June 18<sup>th</sup>, 2024

CHELAN COUNTY NATURAL RESOURCE DEPARTMENT  
LOWER CAMAS MEADOWS RESTORATION PROJECT

**ADDENDUM NO. 2**

CHELAN COUNTY NATURAL RESOURCE DEPARTMENT  
 LOWER CAMAS MEADOWS RESTORATION PROJECT  
 SITE PLAN 1  
 FINAL DESIGN

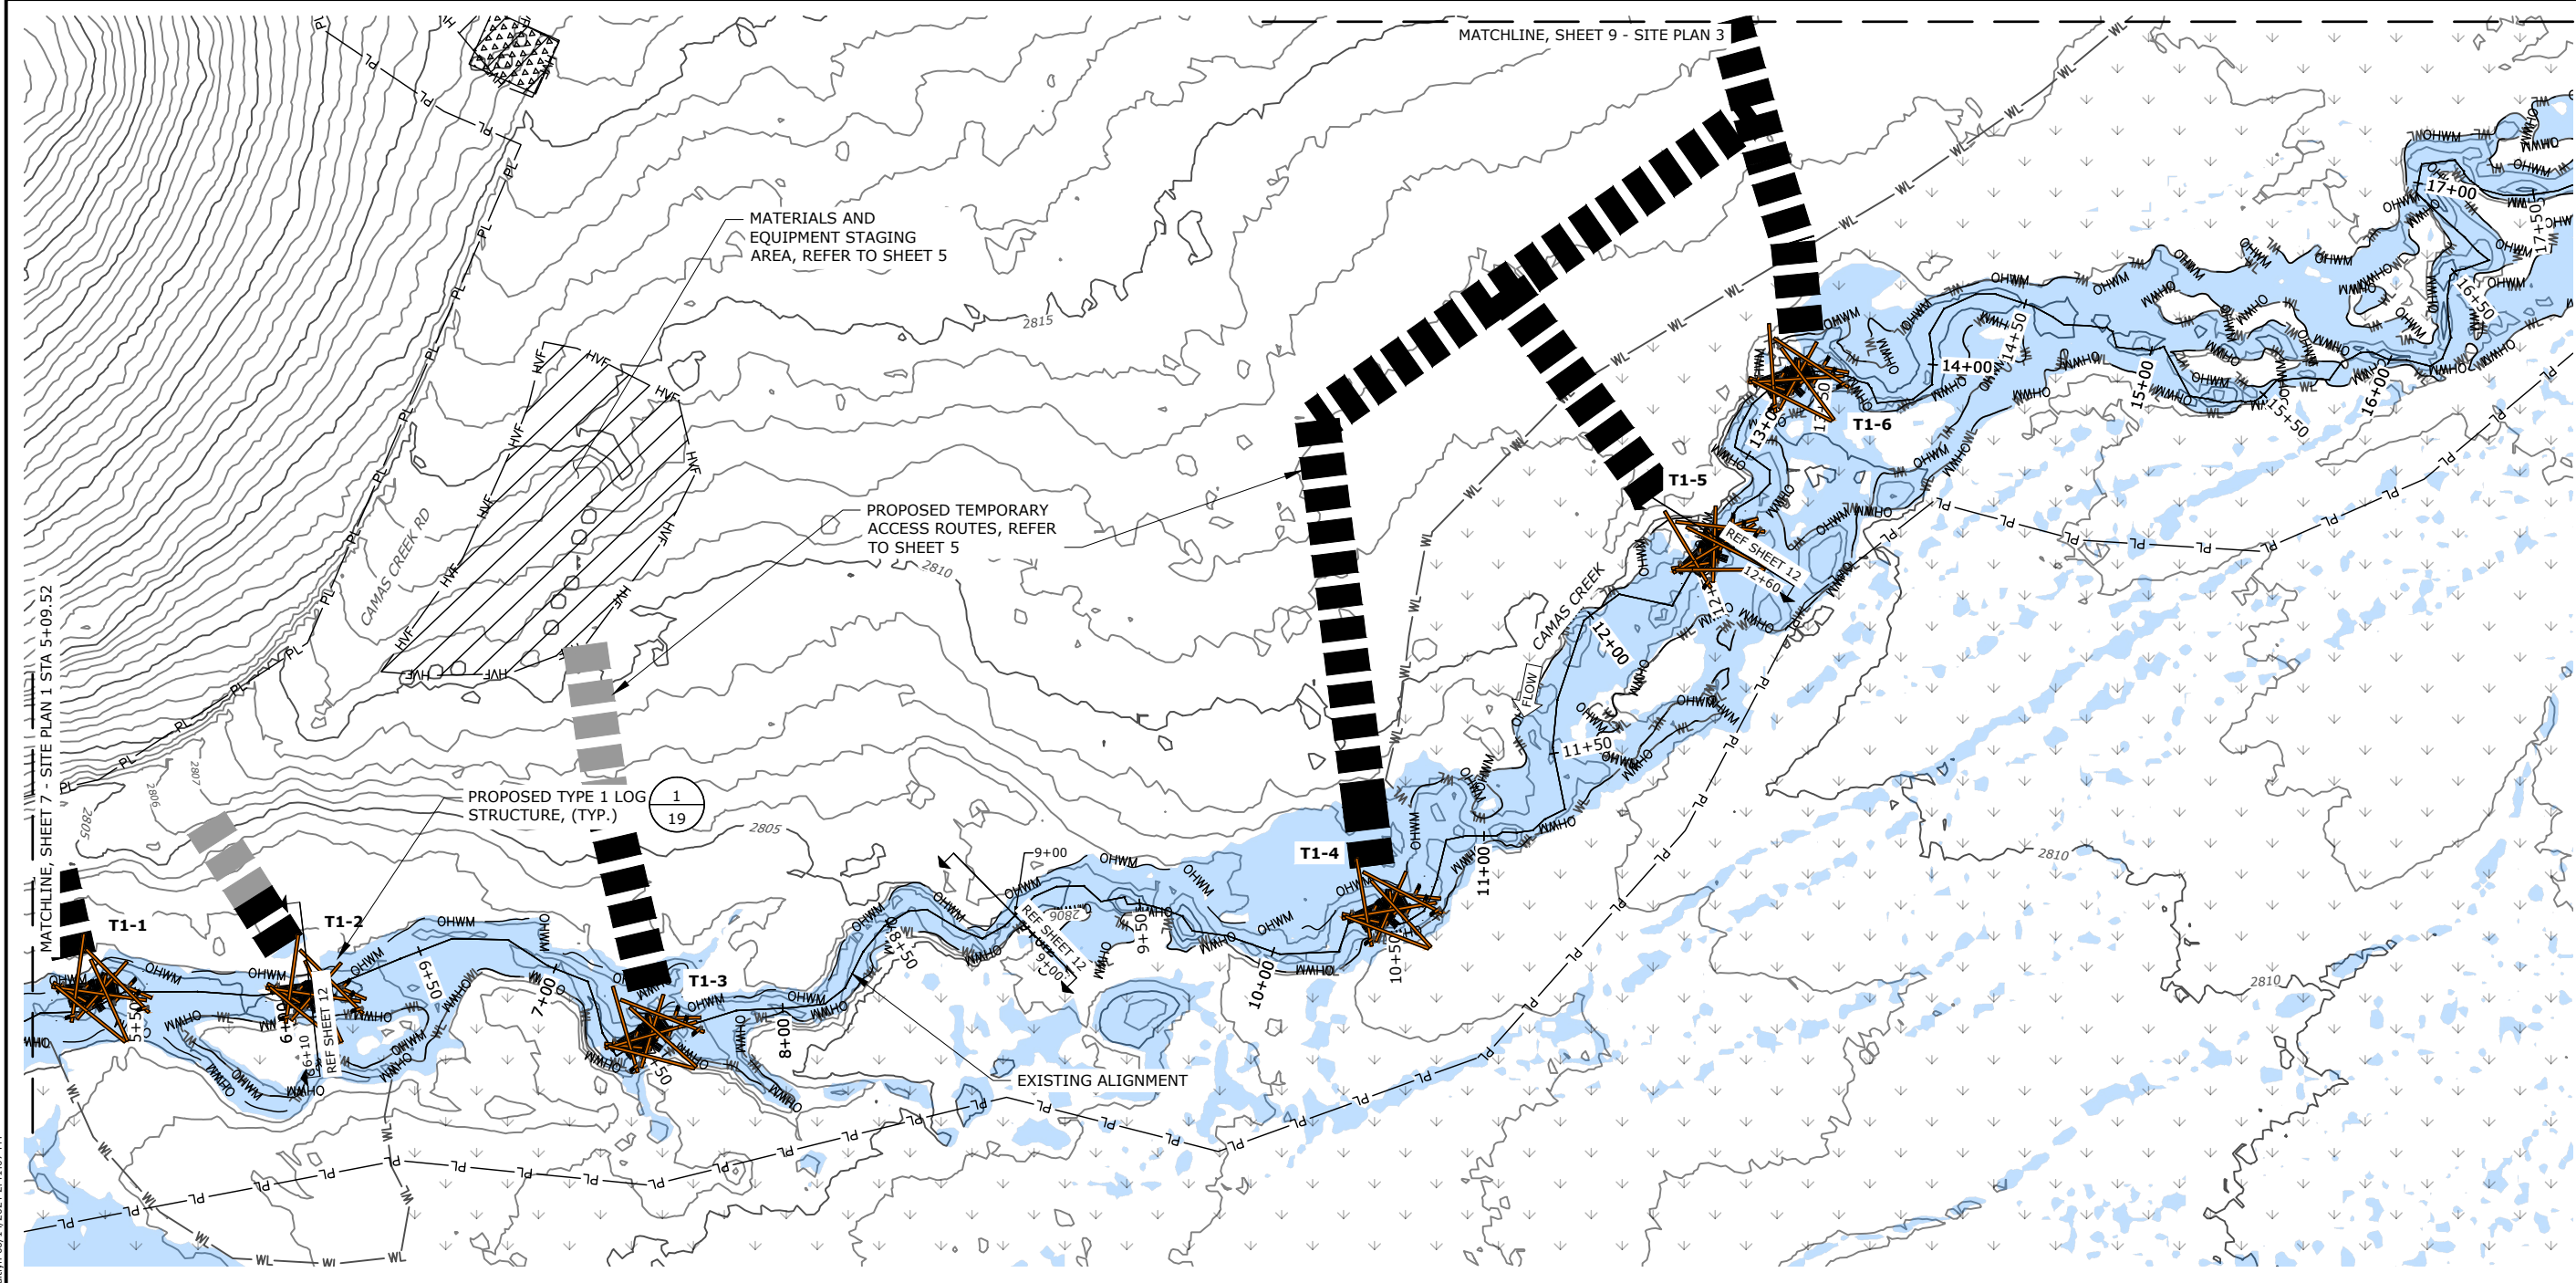
**A.1.** Revisions have been made to sheets 2, 7, 10, 13, 15, 16 and 22, therefore a complete updated planset has been provided and is included as Appendix A to this addendum.

- REMOVE EXISTING 92" PIPE ARCH CULVERT AND REPLACE WITH 15'9" SPAN X 8' RISE ALUMINUM BOX CULVERT. STRUCTURE WILL PROVIDE A 12-FOOT OPEN CHANNEL WIDTH AND 1.5 FT OF FREEBOARD ABOVE THE Q100.

- WHERE LOGS CROSS, INSTALL BOLTED CONNECTION, TOTAL OF 18 THROUGHOUT VALLEY GRADE CONTROL.
- REMOVE AND REPLACE ANY ROADWAY SIGNAGE AS NECESSARY. A TRAFFIC CONTROL PLAN AND DETOUR WILL BE NECESSARY, TO BE DEVELOPED BY THE CONTRACTOR. SEE DETOUR PLAN ON SHEET 21.
